SUBJECT: Cedar River, Cedar Rapids, Iowa, Flood Risk Management Project, Feasibility Study Report with Integrated Environmental Assessment (November 2010) – Documentation of Review Findings

DOCUMENTATION OF REVIEW FINDINGS

**CEDAR RIVER – CEDAR RAPIDS, IOWA
FLOOD RISK MANAGEMENT PROJECT**

**FEASIBILITY REPORT
AND
ENVIRONMENTAL ASSESSMENT**

Figure A- 1 Cedar River 2008 Flood Hydrograph at Cedar Rapids

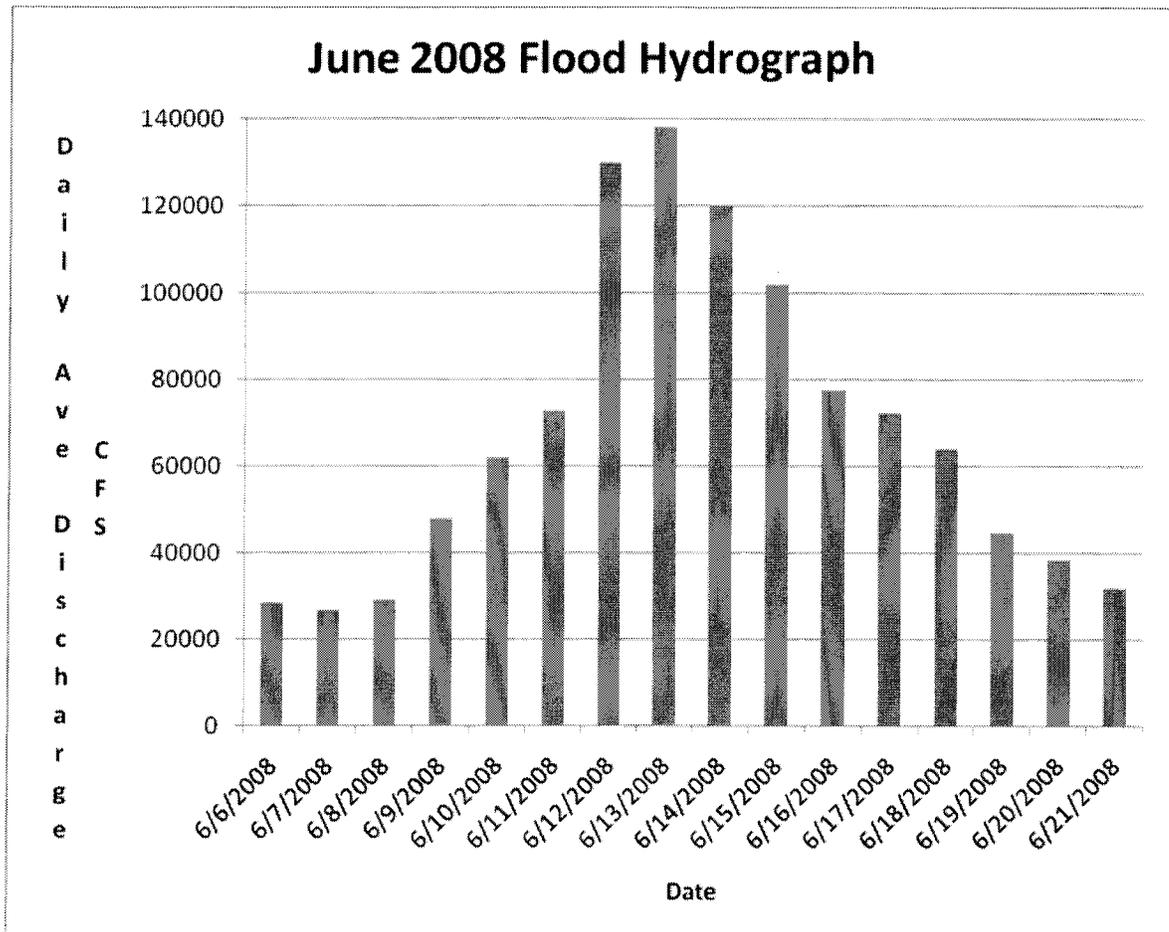
7. Historic Record of Potential Flood Events. It is noted that, for a variety of reasons, the Cedar Rapids area has never experienced significant flooding or a levee failure. The main report contains very little information on flood events that have threatened the CR area. The report should provide information on peak stages that have occurred, by year, at key index points and relate these to the estimated levee failure probabilities at these index points. If there are obvious inconsistencies between the historic record and the estimates developed by the study team these need to be clearly explained. See E-19 j. and k. of ER 1105-2-100 which explains the relevance of historic flood data in determining existing and future flood damages.

CEMVR Response: Concur. Recommended changes have been addressed as proposed. Cedar Rapids has experienced one significant flood in 2008; we have expanded the discussion of the causes of the 2008 flood. Likewise in “Section 3.1.4 General Hydrology in Table 2 Flood of Record” the report provided information on peak flood stages by year at the Cedar Rapids gage for the largest 10 floods of record. We have moved this section to a more prominent location and expanded the material to include discussions of the other significant floods in 1961 and 1993.
